SUBJECT: Forwards response to specific issues raised in SSER & (NUREG-0892) addressing seismic qualification of safety-related electrical & mechanical equipment.

Subject: NUCLEAR PROJECT 2
EQUIPMENT SEISMIC QUALIFICATION
INTERIM REPORT

SAFETY EVALUATION REPORT SUPPLEMENT
NUREG-0892, SUPPLEMENT 3

Model of Impulse Points and Accelerometer Locations

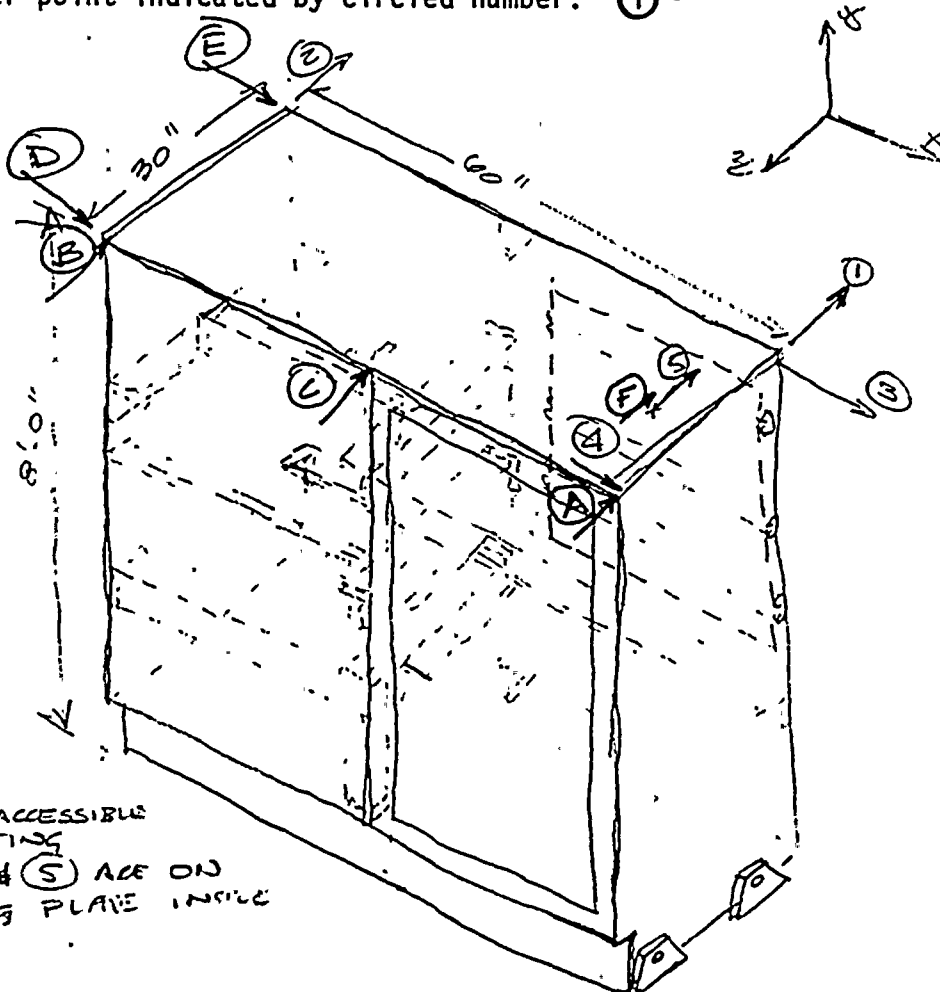
The panel on which this item is mounted was qualified by test. The test consisted of multifrequency, multi-axis, random inputs. Test Response Spectra (TRS) from these tests enveloped the initial Required Response Spectra (RRS). Subsequently, based on further investigation, the RRS was changed, with the result that the TRS did not envelope the RRS in different regions. An effort was made to analyze this apparent inadequacy based on the natural frequency of the system. From this analysis, the lowest natural frequency of the system is estimated as 7.5 Hz. One unenveloped region is around 6.5 Hz, which is too close to the system frequency. As a result, the adequacy of the qualification test is in doubt. The applicant is to justify his present qualification or requalify the equipment."

The Supply System does not agree with audit conclusion that a system frequency of 7.5 Hz exists in the panels. The conclusion was based on a comparison of Response Spectra Data between the control accelerometer and a response accelerometer located inside the control panel that houses the subject pressure switches. In order to provide conclusive data, an in-situ natural frequency test was performed on the control panel and internal component mounting points to determine a more accurate natural frequency behavior of the panel.

The attached test report, "Frequency Test for Hydrogen Recombiner Panel (0740-024-1351)" demonstrates that the lowest natural frequency (Structural or local) is 28.3 Hz, which is well above the nonenveloped portion of Required Response Spectra.

IN-SITU TEST CANDIDATE SELECTION PROCESS

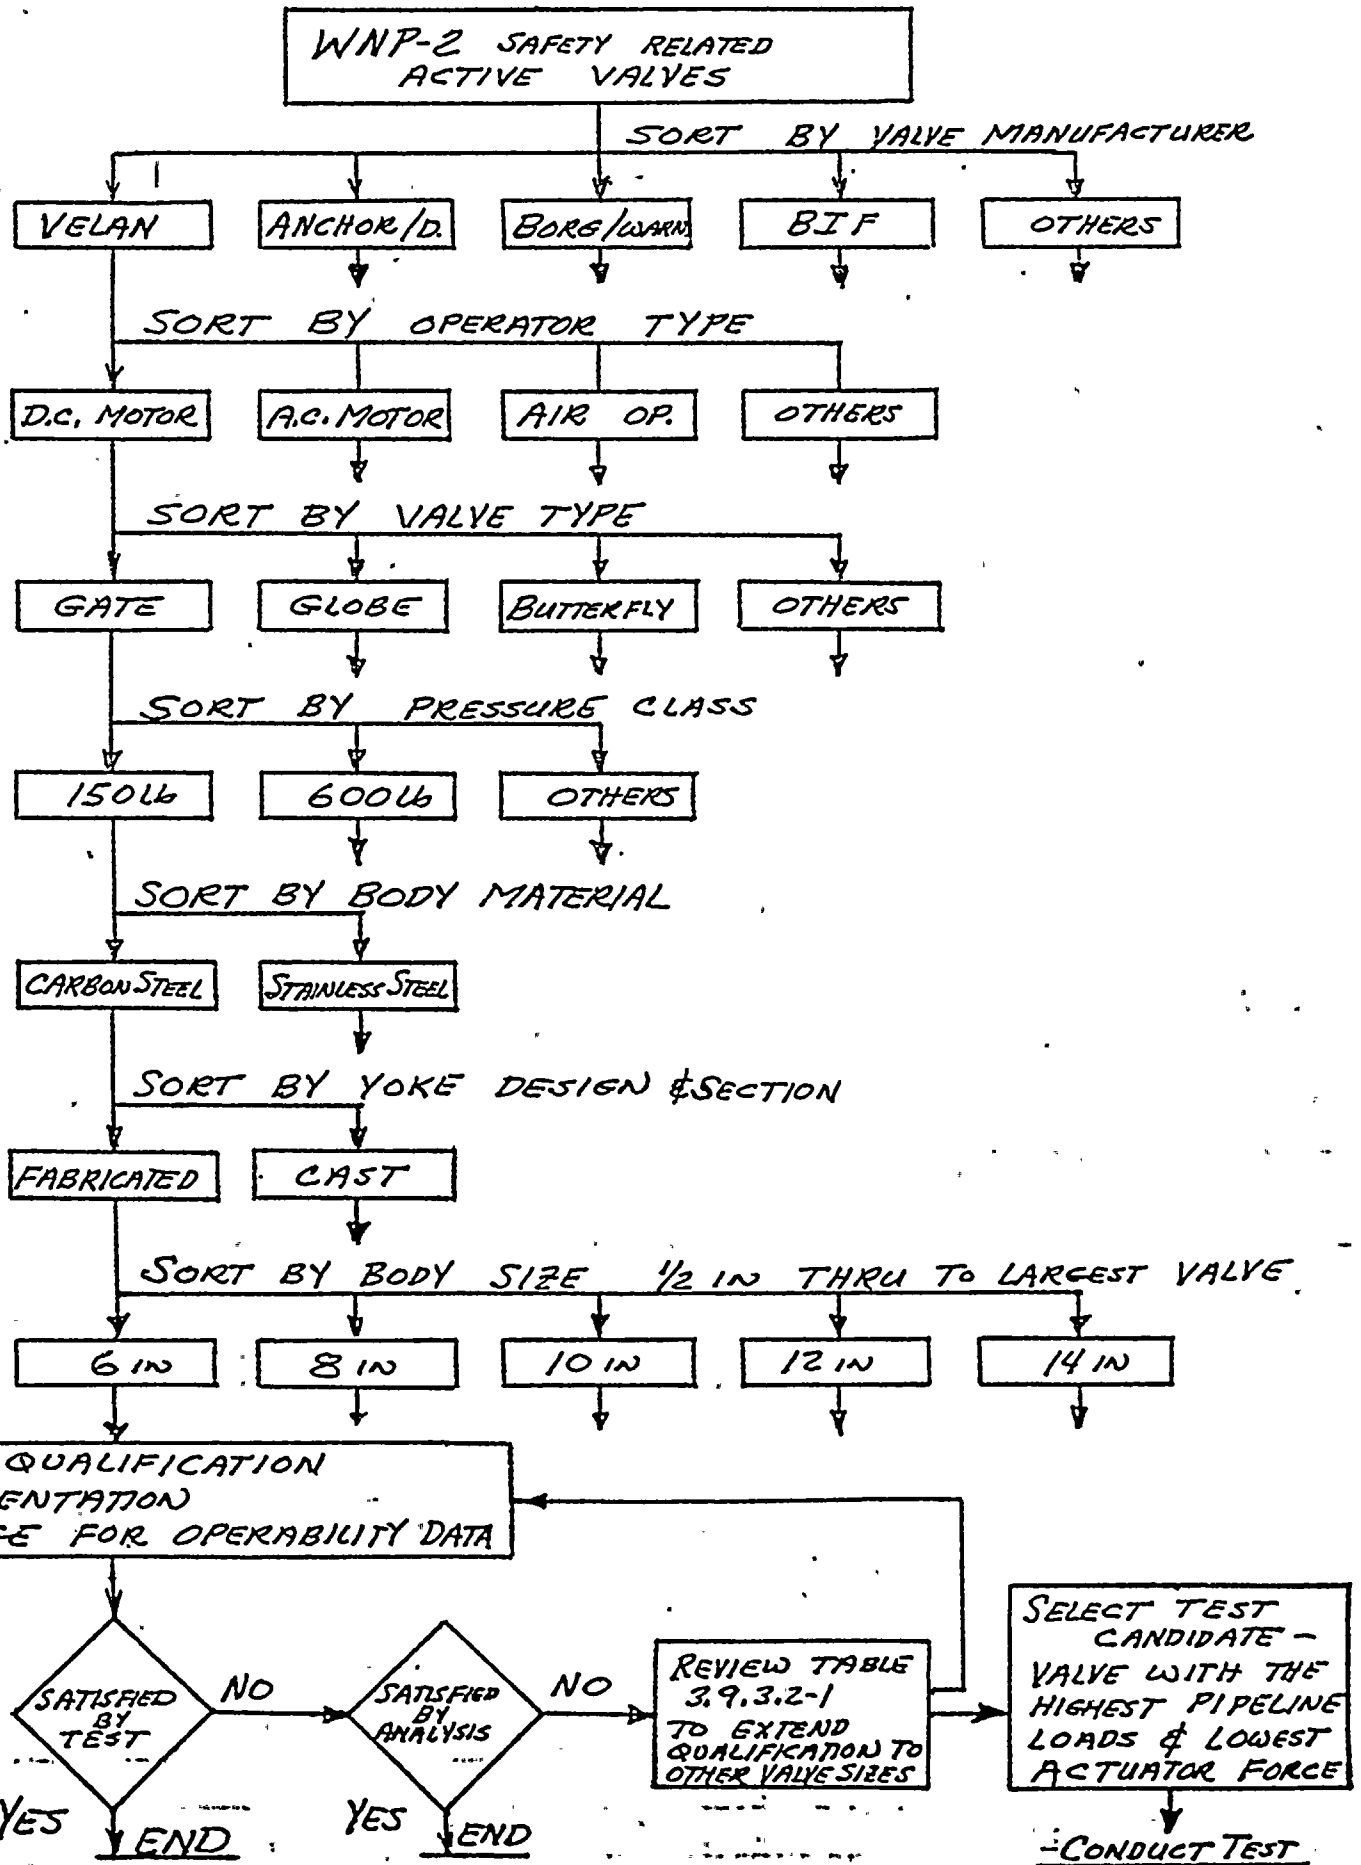
"...provide a discussion of how you establish the similarity of valves to a tested prototype. This discussion should include, but not be limited to, those characteristics such as valve type, size, geometry, pressure rating, stress level, manufacturer, actuator type, and actuator load rating."

The test candidates were chosen from "families" of valves (see attached flow chart). All safety-related active valves were first segregated by valve supplier, then actuator type (i.e., electrical AC, electrical DC, air, hydraulic). These groups were then further categorized by type (i.e., gate, globe, butterfly), pressure class, body material (i.e., carbon steel, stainless steel), yoke leg configuration, and pipeline size.

Test candidates were chosen from these resulting "families" based on the highest dynamic and operating loads compared to the lowest available actuating force (i.e., motor operator - available torque output). The use of an operability test to establish qualification was limited to its "family" and to additional similar "families" different only in connecting pipe size and only within the size ranges defined in Table 3.9.3.2-1 (attached).
